SUBJECT: MILLSTONE POWER STATION, UNIT NO. 2 - ISSUANCE OF AMENDMENT
RE: TECHNICAL SPECIFICATION CHANGES FOR SPENT FUEL STORAGE
(TAC NO. MF0435)

Amendment No. 327
Renewed License No. DPR-65

ATTACHMENT TO LICENSE AMENDMENT NO. 327

FIGURE 3.9-1A MINIMUM REQUIRED AVERAGE FUEL ASSEMBLY BURNUP AS A FUNCTION OF INITIAL ENRICHMENT TO PERMIT STORAGE IN REGION 2A

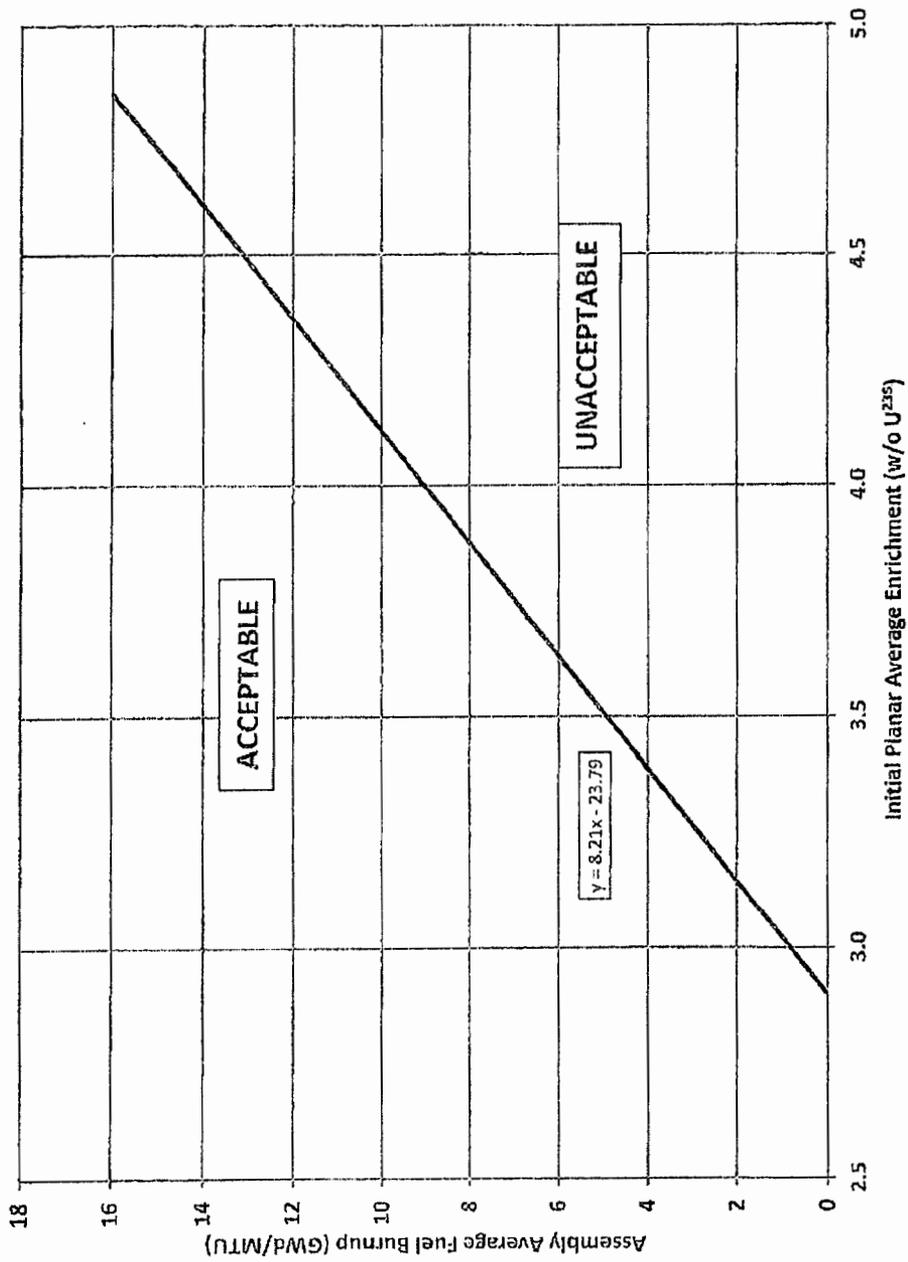
- (b) Region 2 has two types of storage locations:
 - (1) The combination of initial planar average enrichment and burnup of a fuel assembly stored in Region 2 Type 2A shall be within the acceptable burnup domain of Figure 3.9-1A.

FIGURE 3.9-1B MINIMUM REQUIRED AVERAGE FUEL ASSEMBLY BURNUP AS A FUNCTION OF INITIAL ENRICHMENT TO PERMIT STORAGE IN REGION 2B

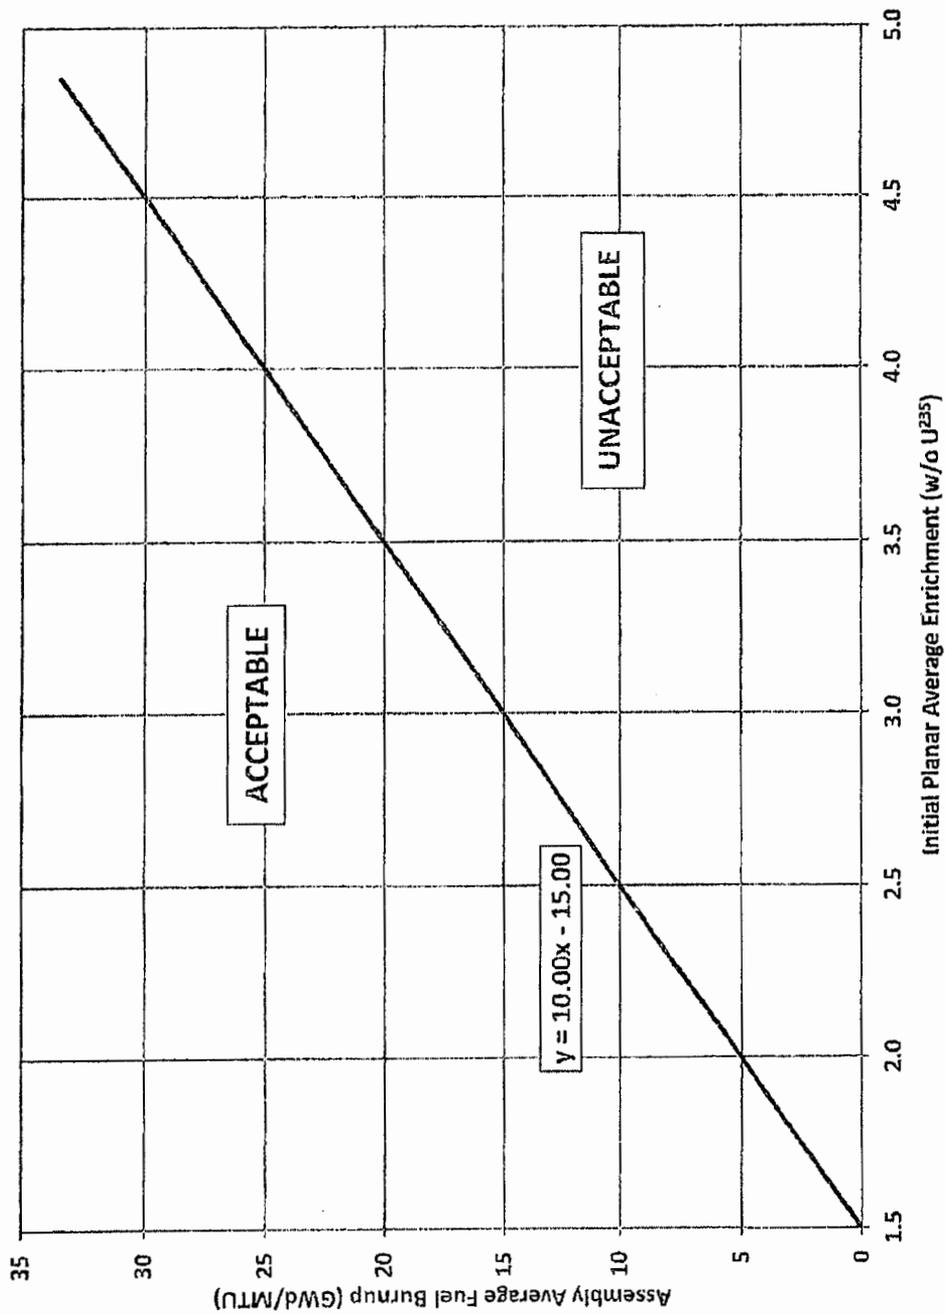
- (2) The combination of initial planar average enrichment and burnup of a fuel assembly stored in Region 2 Type 2B shall be within the acceptable burnup domain of Figure 3.9-1B.

Figure 3.9-1C MINIMUM REQUIRED AVERAGE FUEL ASSEMBLY BURNUP AS A FUNCTION OF INITIAL ENRICHMENT TO PERMIT STORAGE IN REGION 3 (with insertion of 3 Borated Stainless Steel Poison Rodlets)

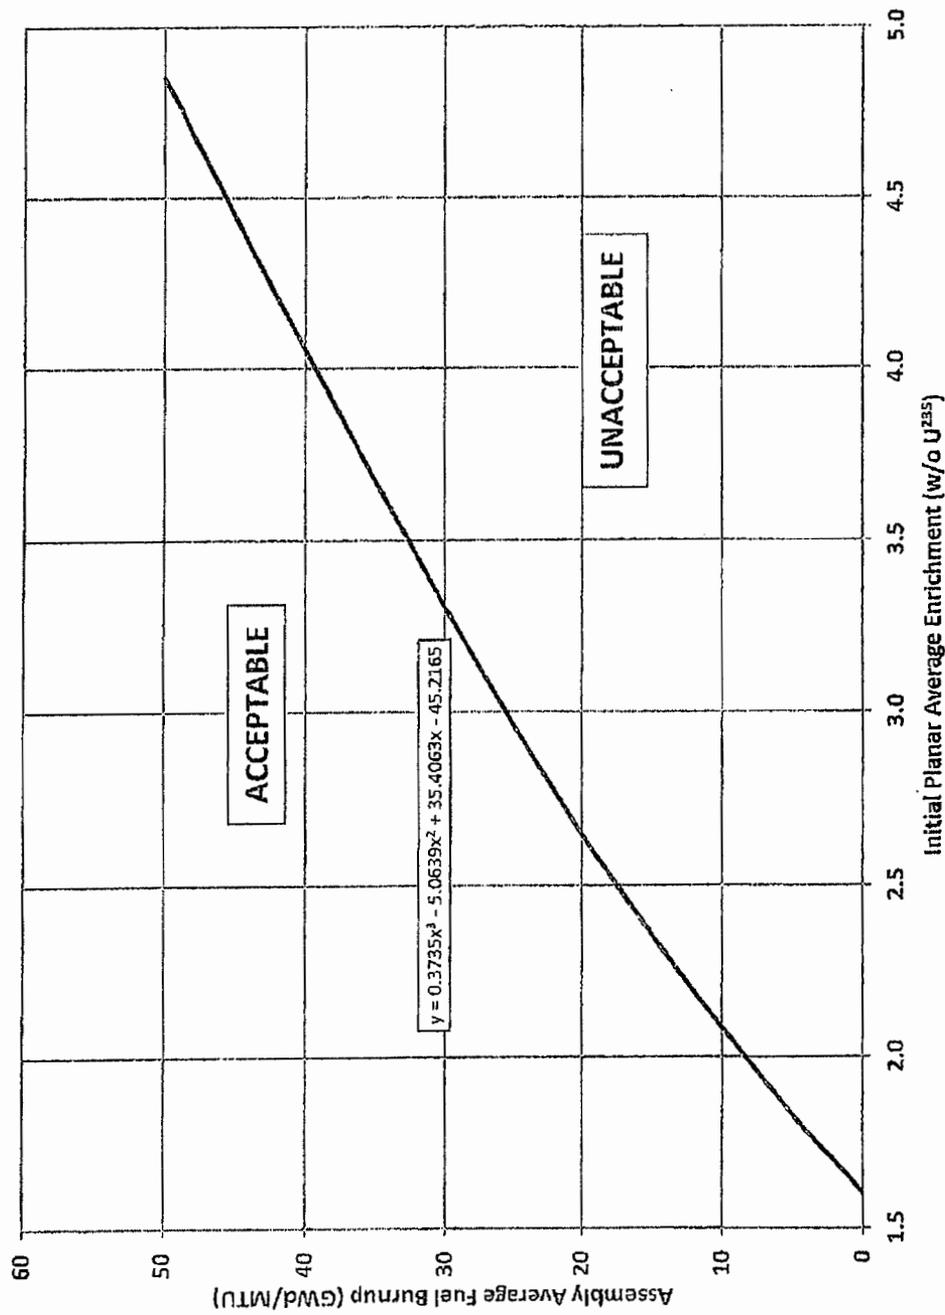
- (1) The combination of initial planar average enrichment and burnup of a fuel assembly containing Borated Stainless Steel Poison Rodlets stored in Region 3 shall be within the acceptable burnup domain of Figure 3.9-1C. The Borated Stainless Steel Poison Rodlets shall be installed in the assembly's center guide tube and in two diagonally opposite guide tubes.

Three rodlets are already inserted into the guide tubes of each fuel assembly stored in Region 3 of the pool and whose enrichment-burnup characteristics conform to the requirements given in Figure 3.9-1C of the modified TS. The rodlets are made of borated stainless steel containing 2 weight percent of boron.

Figure 3.9-1D MINIMUM REQUIRED AVERAGE FUEL ASSEMBLY BURNUP AS A FUNCTION OF INITIAL ENRICHMENT TO PERMIT STORAGE IN REGION 3 (with insertion of a full length, full strength Control Element Assembly)

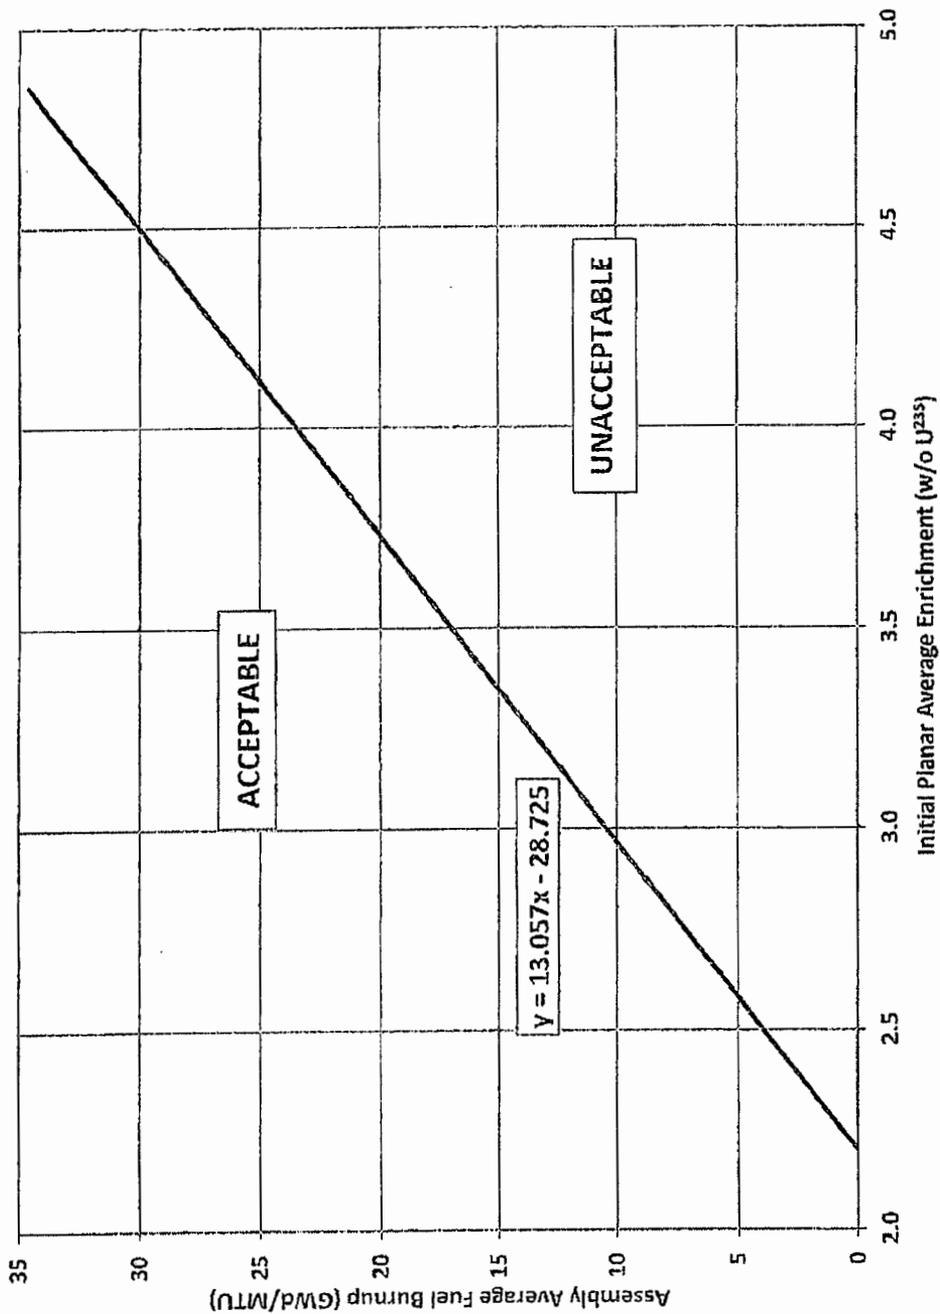
- (2) The combination of initial planar average enrichment and burnup of a fuel assembly containing a full length, full strength Control Element Assembly stored in Region 3 shall be within the acceptable burnup domain of Figure 3.9-1D.*

FIGURE 3.9-1E MINIMUM REQUIRED AVERAGE FUEL ASSEMBLY BURNUP AS A FUNCTION OF INITIAL ENRICHMENT TO PERMIT STORAGE IN REGION 4

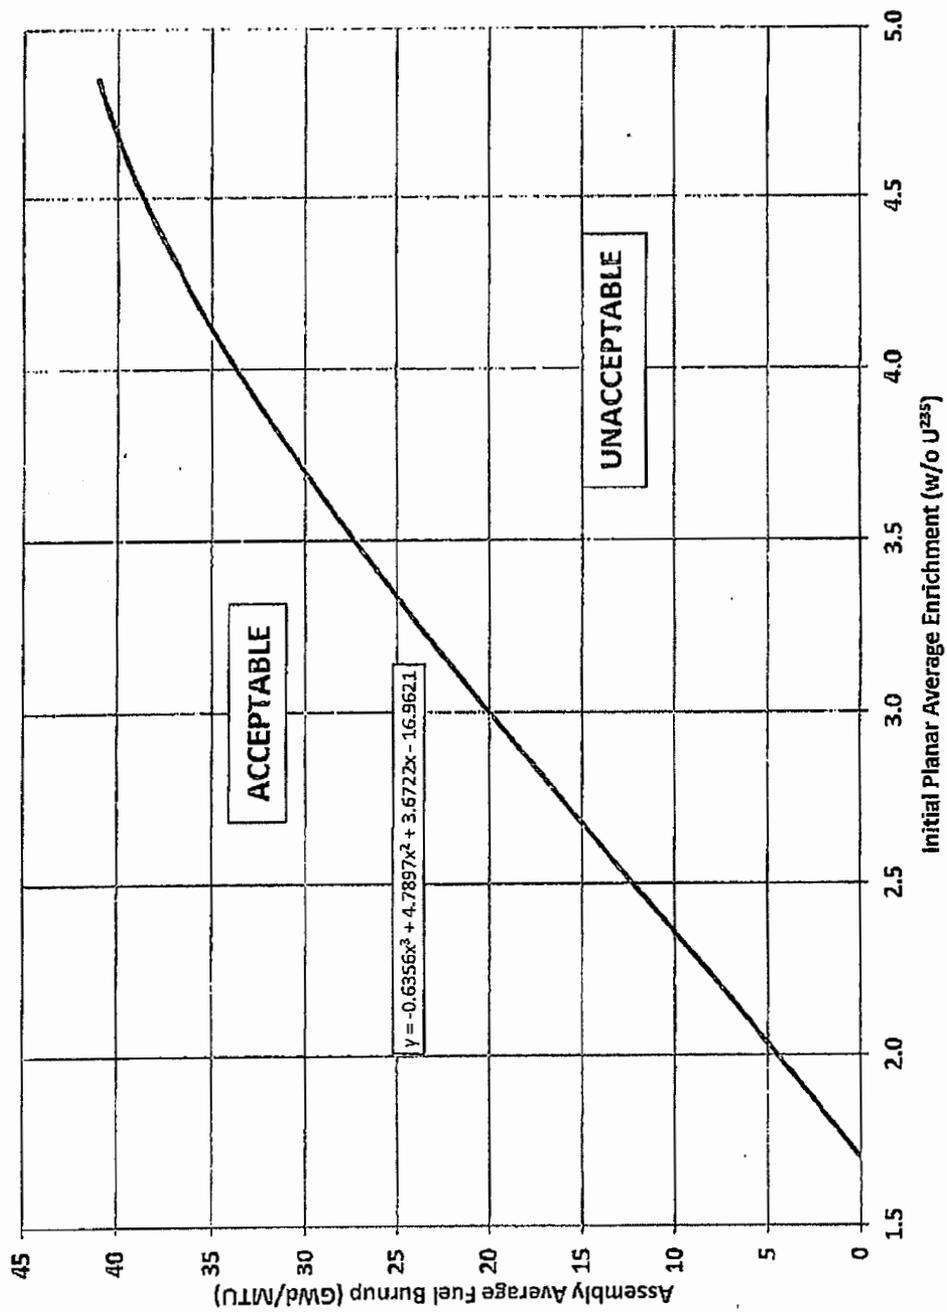
- (d) The combination of initial planar average enrichment and burnup of a fuel assembly stored in Region 4 shall be within the acceptable burnup domain of Figure 3.9-1E.

h) Region 4 of the spent fuel storage pool is designed and shall be maintained with a nominal 9.0 inch center to center distance between storage locations. Region 4 contains Restricted Locations as shown in Figure 3.9-2. Fuel assemblies stored in this region must comply with Figure 3.9-1E.

SPENT FUEL POOL ARRANGEMENT
 FIGURE 3.9-2
 (NOT TO SCALE)

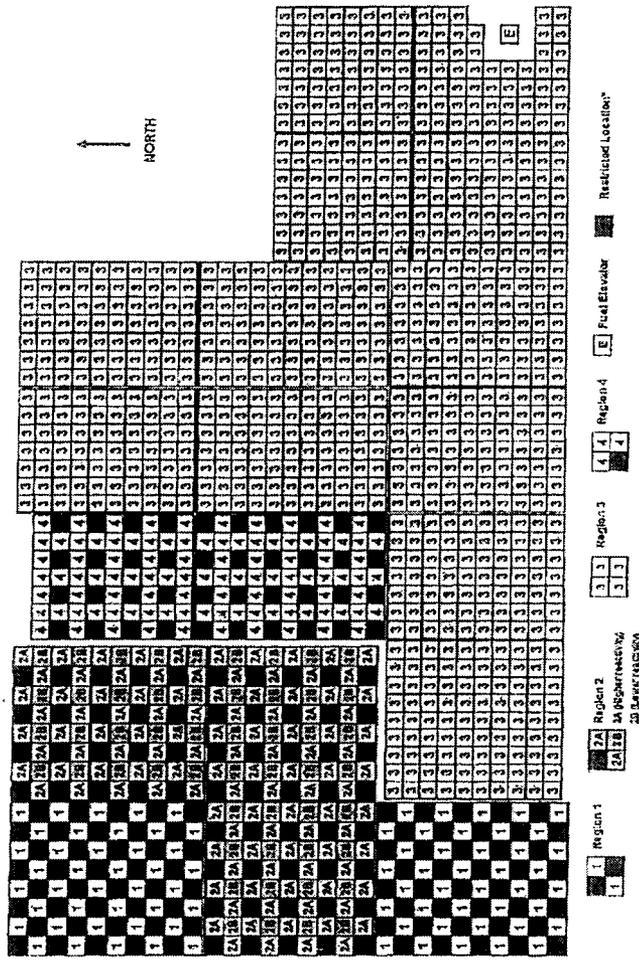
* A Restricted Location shall remain empty. No fuel assembly, no Non-standard Fuel Configuration, no non-fuel component, nor any hardware/material of any kind may be stored in a Restricted Location.

- (1) Restricted Locations shall remain empty. No fuel assembly, no Non-standard Fuel Configuration, no non-fuel component, nor any hardware/material of any kind may be stored in a Restricted Location (shown in Figure 3.9-2).
- (2) Fuel assemblies and Non-standard Fuel Configurations shall NOT be stored in Region 1 and 2 storage locations in which the Boraflex panel box has been removed. It is permissible to store non-fuel components in non-restricted locations with or without a Boraflex panel box. *

Figure 3.9-2 in the proposed TS provides a graphical representation showing the locations of each region and the required empty or "restricted" locations. As is noted on the figure, storage of fuel or non-fuel components in restricted locations is not permitted.
